Product / Process Change Notification (PCN)

PCN #: PCN_IndPD_20200327
Affected Series: WE-PD 1280; 744770xxx,

PCN Date: December 27, 2019
Effective Date: March 27, 2020

Label example for pad printing
(13th digit marked in red)

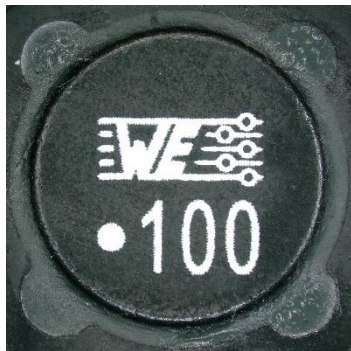
- 1.) All electrical and mechanical properties of the parts will remain the same.
- 2.) Pad- and Laser-Printing will be used from now on.
- 3.) Printing method can be identified on the label by the 13th digit in the lot number.

Lot.-No. for Pad-Printing: xxxxxxxxxxx0xx

Lot.-No. for Laser-Printing: xxxxxxxxxxx6xx
